Administrative Approval Action

Case File / Name: ASR-0106-2021 DSLC - HAYES BARTON BAPTIST CHURCH EXPANSION

LOCATION:	This site is located on the north side of Glenwood Avenue, north of W. Whitaker Mill Rd at 1800 Glenwood Avenue.
REQUEST:	Development of an existing 5.65 acre tract zoned R-10. Two proposed additions totaling 925 sf (450 sf vestibule & 475 sf kitchen) to an existing place of worship (Civic Use) facility of 100,240 sf, totaling 101,165 sf. Improvements also include a new vehicular parking lot, with lighting and a recombination of existing lot lines, adding 35 new additional spaces to the existing parking spaces (141) totaling 176 spaces overall meeting the required parking standards per TC-11-21, no maximum parking allowance.
DESIGN ADJUSTMENT(S)/

A-2.1

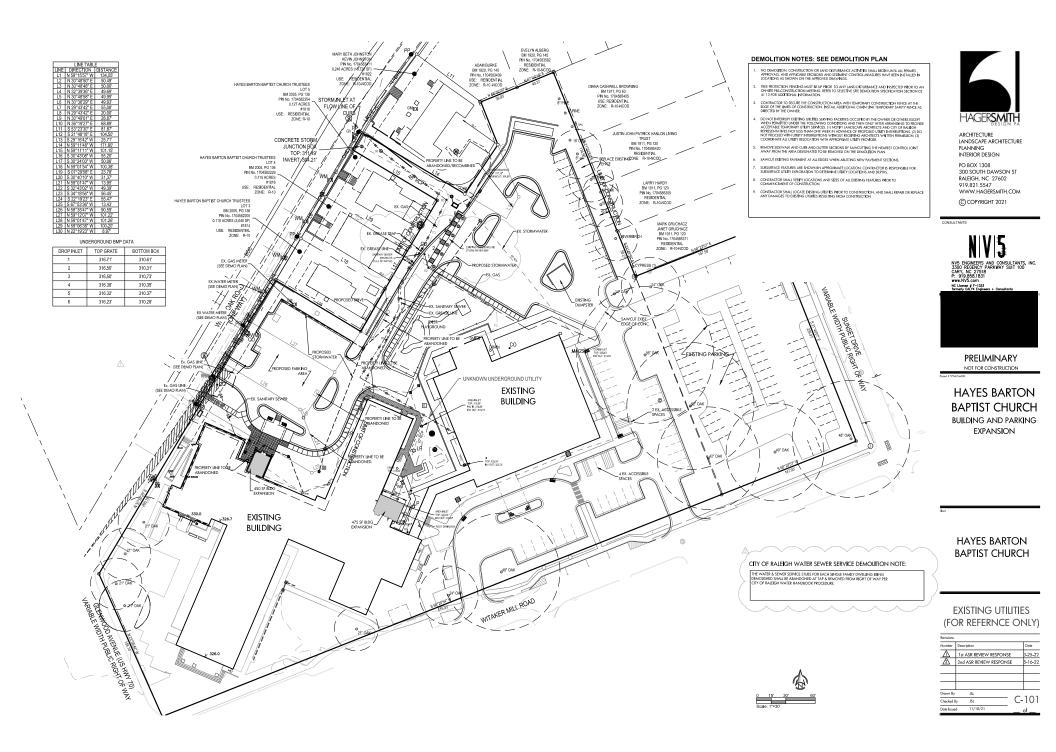
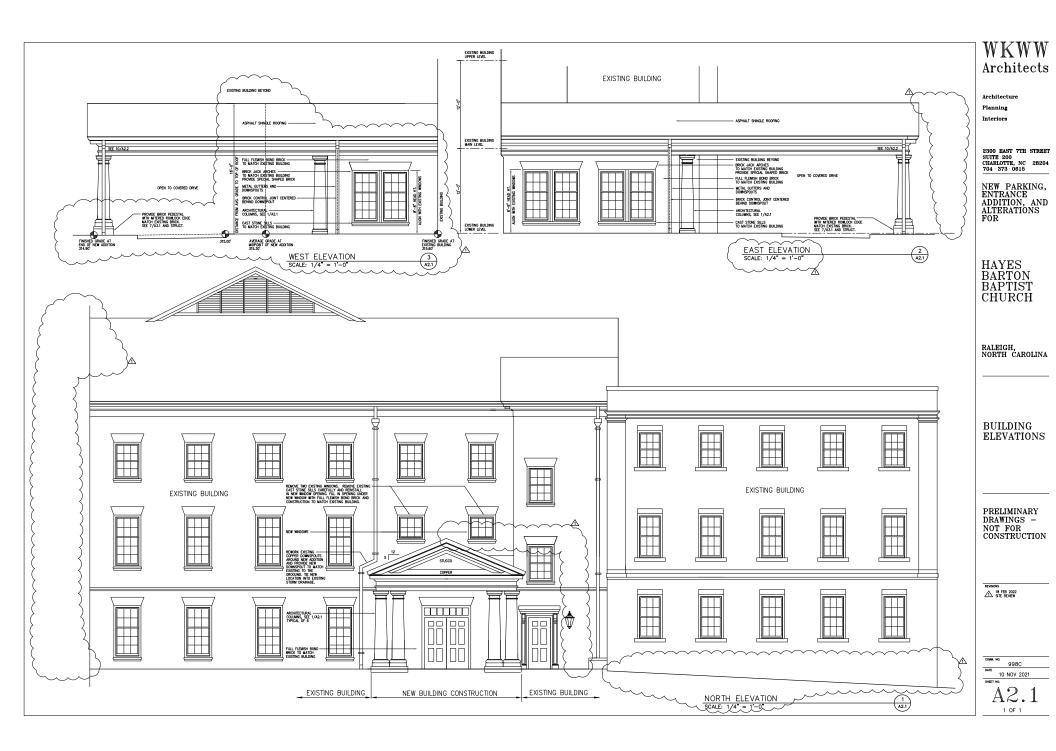
- 1. Revise elevations sheet A2.1; East Elevation's (kitchen addition) spot grades are relabeled showing the Post-Development Avg. Grade #s in accordance with Sec.1.5.7.A & or TC-4-20 ('high', 'low' & 'avg' grades should be labeled & spotted as such), on the Site Permit plans elevation sheet. A height dimension is provided, measured and shown from the 'post-development' average grade # in accordance with UDO Sec.1.5.7.A.

- 2. Revise elevations sheet A2.1, West Elevation's (vestibule entrance addition) spot grades are relabeled showing the Post-Development Avg. Grade #s in accordance with Sec.1.5.7.A & or TC-4-20 ('high', 'low' & 'avg' grades should be labeled & spotted as such), on the Site Permit plans elevation sheet. A height dimension is provided, measured and shown from the 'post-development' average grade # in accordance with UDO Sec.1.5.7.A..
